AS-BUILT

PROJECT:
RESIDENCE AT STRATMOOR HILLS
FILING NO. 2
HARTFORD STREET/WILSHIRE DRIVE
COLORADO SPRINGS, COLORADO

DETENTION POND MODIFICATIONS

DETENTION PONDI MODIFICATIONS
OUTLET STRUCTURE

OUTLET STRUCTURE DETAIL PLAN VIEW

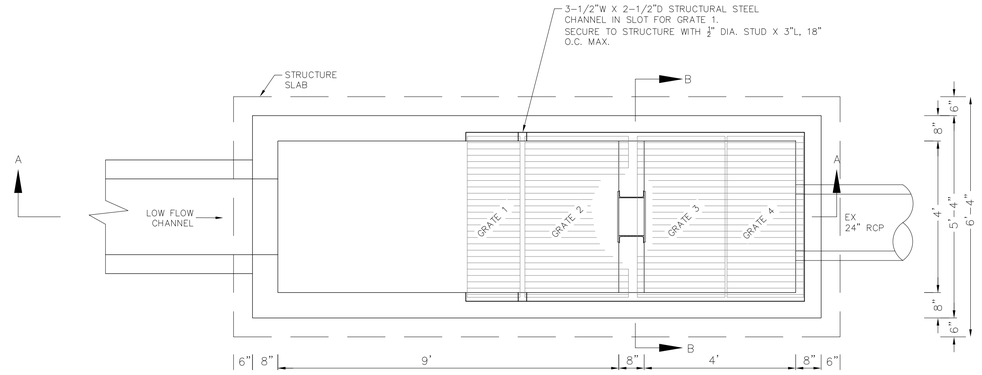
Since this grate is ~1ft lower than designed we'll need to see revised MHFD-Detention calcs that reflect these as-built conditions to see the change of the drain time and release flows compared to the original design inputs.
